TECHNICAL BULLETIN

[Issue No.] T03-0012-A

[Title] Production discontinuation of Memory cassette for A2S(S1)/A2AS(S1/S30/S60)/A2USHCPU-S1

[Date of Issue] August 2001 (Ver. A: October 2014) [Relevant Models] A2SMCA-14KP, A2SWA-28P

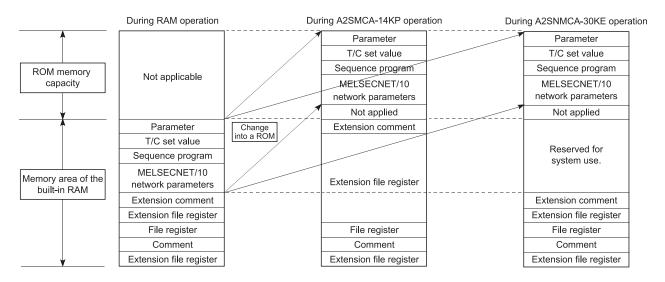
The applicable range in built-in RAM area varies with the memory cassettes as shown below.
